SERVICE BULLETIN

REFERENCE BODY
NUMBER 001
DATE 05-22-87
MODEL ALL

WIPER LINKAGE

IMPROVEMENTS OF WIPER LINKAGE

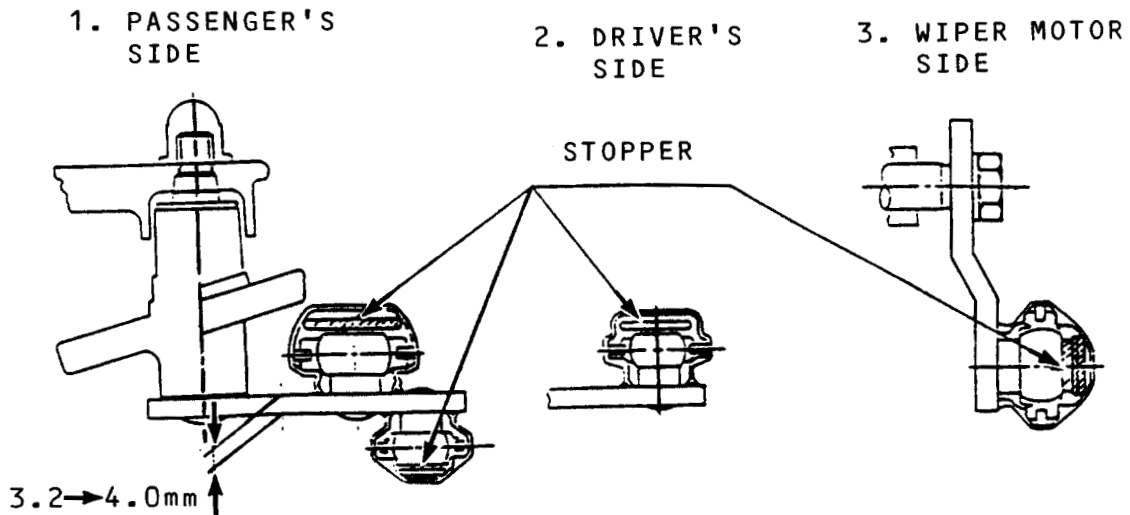
To increase rigidity of the wiper linkage, the ball socket joint has been revised as shown below:

New Motor Assembly, Link Assembly and Arm Assembly are interchangeable as a set only.
